Re: FortisBC Energy Inc. (FEI)

Project No. 1599129

**Application for a Certificate of Public Convenience and Necessity (CPCN) for
the Pattullo Gas Line Replacement Project (the Application)**

Response to the City of Burnaby (Burnaby) Information Request (IR) No. 1

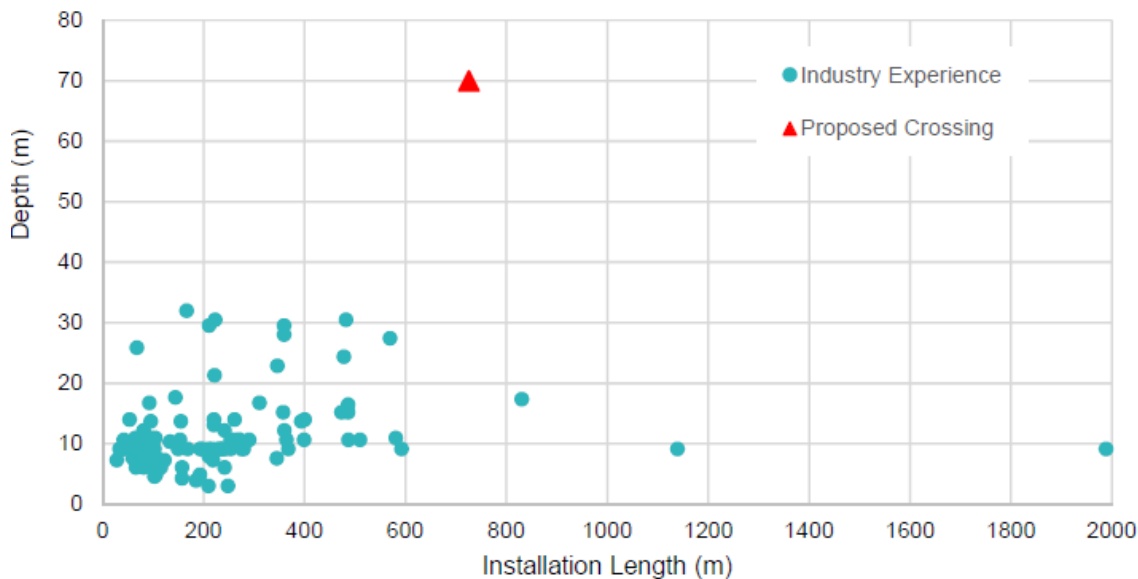
9.1 At lines 16-19 of page 34, FEI states that 750 meters depth and 70 meters length would be the longest and deepest attempts at micro-tunneling in North America. Please advise if micro-tunneling has been successful elsewhere than North America at lengths and depths that exceed those values.

To further illustrate the unprecedented nature of the suggested micro-tunnel, FEI provides the following graph from the Microtunnel Feasibility Memo³ included as in the response to BCUC IR1 7.4, Attachment 7.4.

³ Figure 3-1 from P-00758-PIP-MEM-0005 Microtunnel Feasibility Memo prepared by Kiewit/Mott Macdonald.

Figure 1: Map Showing Potentially Impacted Private Lands on Broadway & Gagliardi Way Corridor

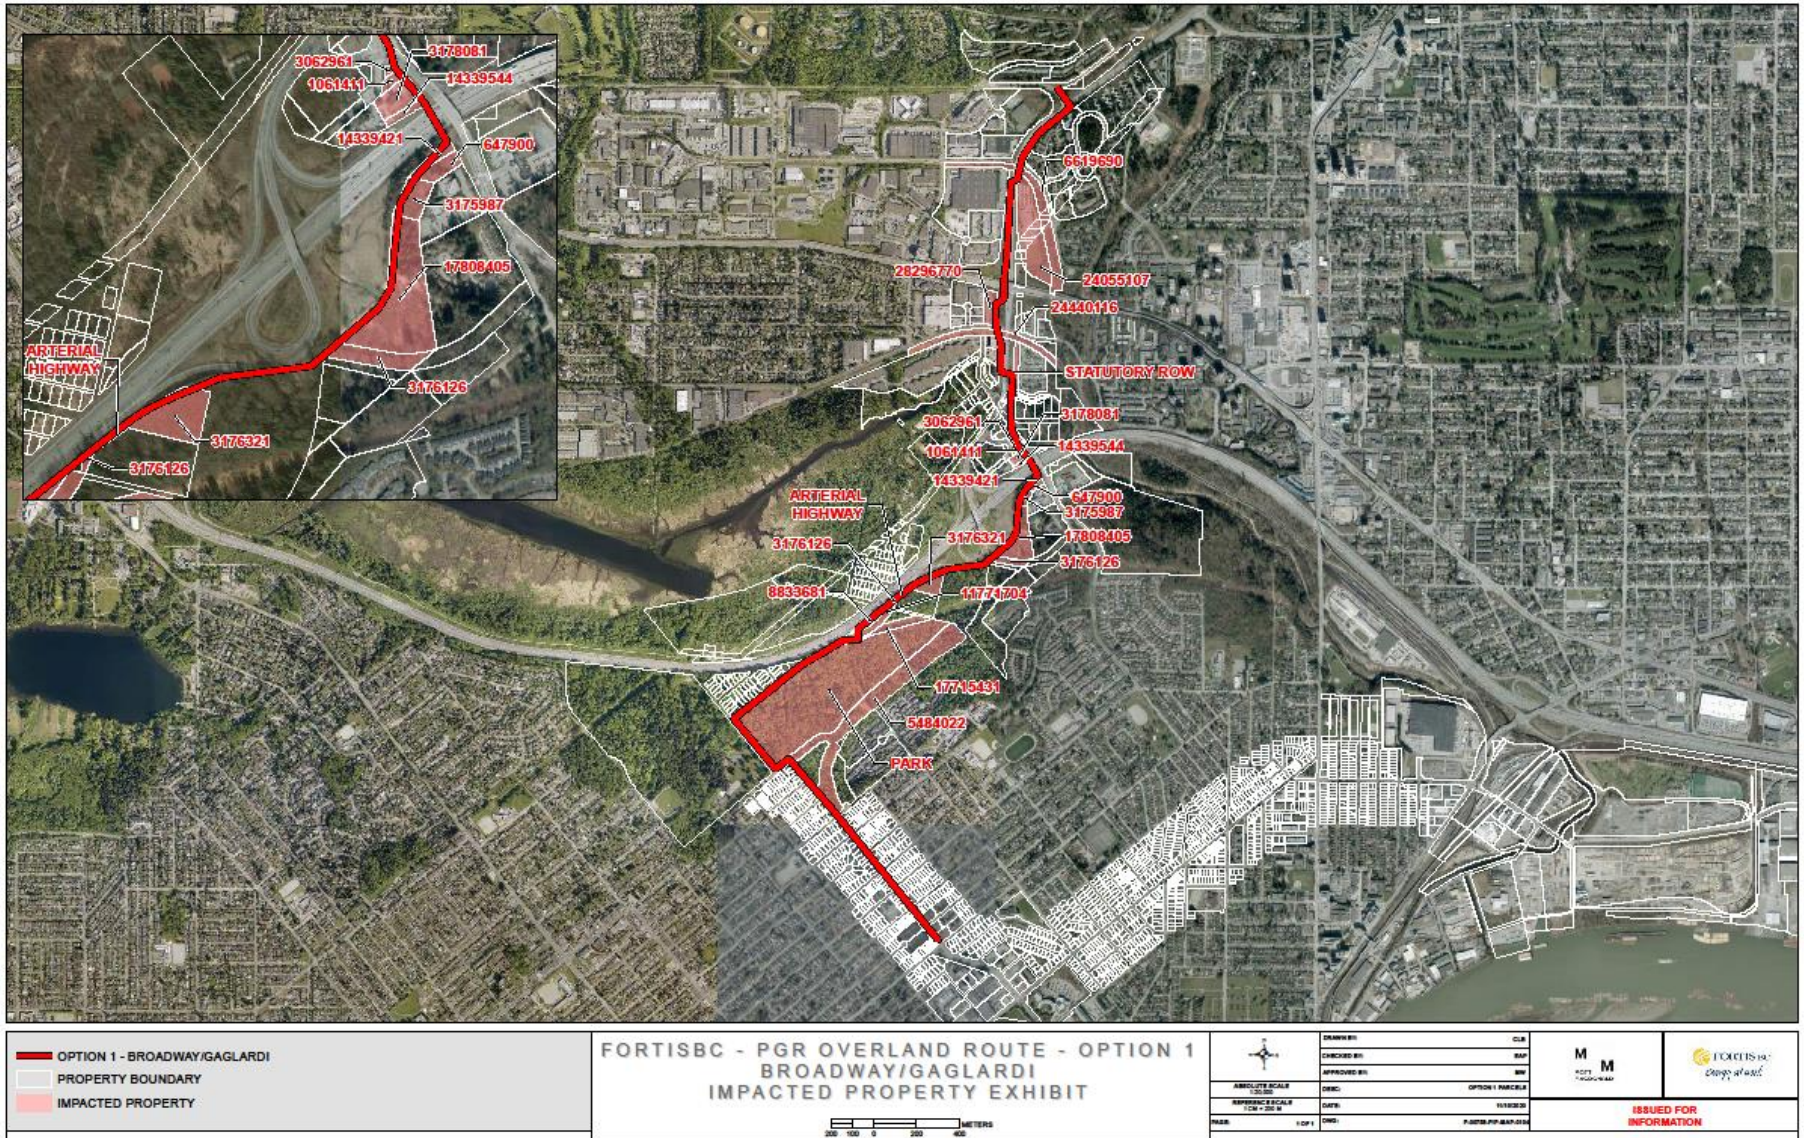
- 1 12.13.1 the Broadway & Gaglardi Way Corridor,
- 2 12.13.2 the Cape Horn Gate Corridor, and
- 3 12.13.3 the Fraser Gate Corridor.
- 4

6 Below is a map of the Broadway & Gaglardi Way route Corridor, outlining potentially affected
 7 business in the orange shaded area. FEI estimates that there would be fewer than 10
 8 businesses potentially affected along this corridor. The primary access for businesses to the
 9 west of Gaglardi Way is via Production Way, which is not anticipated to be impacted by the
 10 Project.

Figure 3-5: Mott MacDonald Hydraulic Fracture Evaluation of Route A1 - Drilled from North Side to South Side of the Crossing

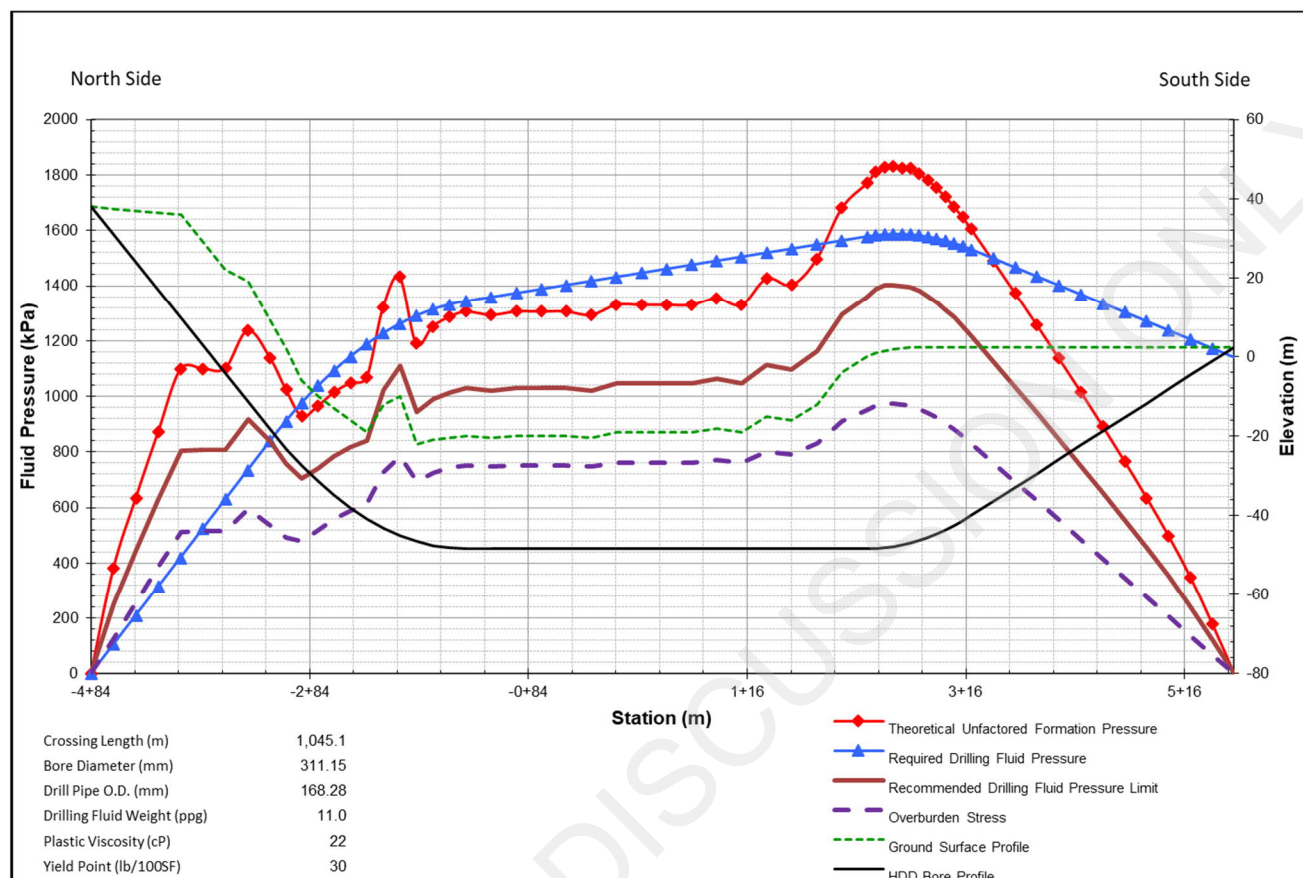
Response:

In Figure 3-5 of the report (page 12), the hydraulic fracture evaluation demonstrates a loss of drilling fluid pressure once the pilot hole advanced approximately 200 metres. The failure is caused primarily by significant uncertainty of subsurface conditions including poor geological conditions, topography changes in New Westminster and the limited depth of cover.

- As illustrated in Figure 3-5, required drilling fluid pressures exceed the recommended drilling fluid pressure (the blue solid line crosses above the brown solid line) (and the maximum theoretical allowable drilling fluid pressure – red solid line) as the pilot bore is advanced from the north side beneath the Fraser River. Based on this evaluation, full drilling fluid losses would be expected once the pilot bore is advanced approximately 200 m. It is important to note that once drilling fluid losses occur, they may not be able to be restored. Hence, all drilling fluids may migrate up into the Fraser River environment. Further, it may not be possible to remove cuttings from the bore resulting in difficulty passing tooling through the bore and installing the product pipe. The only way to mitigate this risk is to attain more depth of cover beneath the Fraser River or decreasing the starting elevation of the HDD installation on the north side of the crossing. Hence, it is not possible to complete the entire HDD installation from the south side at the given installation depth.
